- A. Water Quality Plan MR 2013019: Mandatory Referral for Stringtown Road**
B. Forest Conservation Plan MR 2013019: Mandatory Referral for Stringtown Road
C. Forest Conservation Plan Amendment 820020220: Highlands at Clarksburg
D. Forest Conservation Plan Amendment 820030020: Clarksburg Village, Phase 1

Staff Report Date: February 14, 2013

Stringtown Road

Figure 4: Clarksburg Village FCP
Additional Encroachment Areas

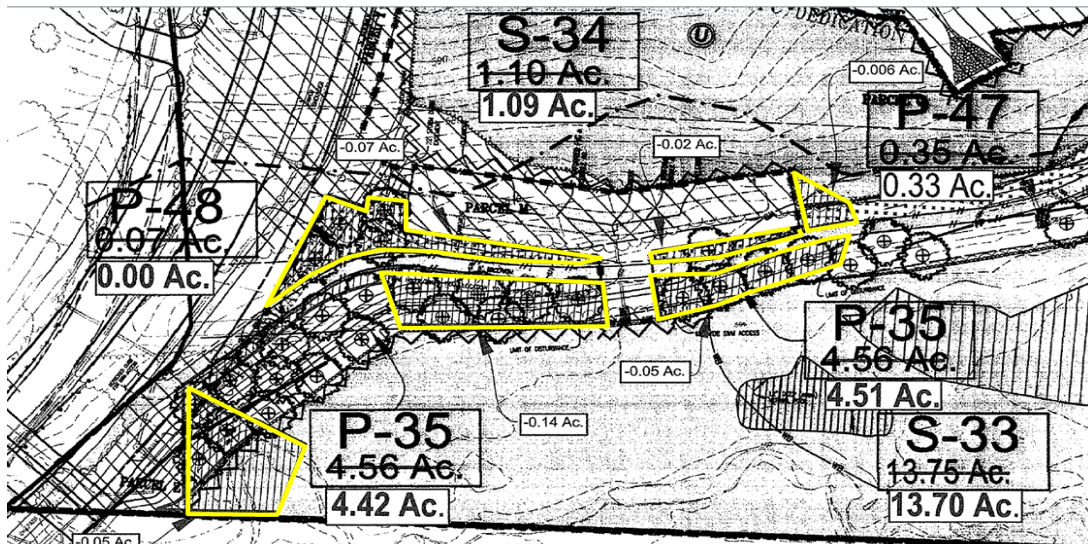
Both plans accounted for the widening and realignment of Stringtown Road. Due to the expanded area now required for stormwater management, an additional 0.14 acres of forest from the Highlands of Clarksburg and 0.34 acres of forest from Clarksburg Village will be removed. Loss of forest requires replacement at a 2:1 ratio; the standard when easement area is permanently removed, but not replaced onsite.

Staff also recommends **Approval** of the Forest Conservation Plan Amendment 820030020: Clarksburg Village, Phase I, subject to the following condition:

1. Mitigate forest loss at a 2:1 basis within the Seneca Creek watershed.
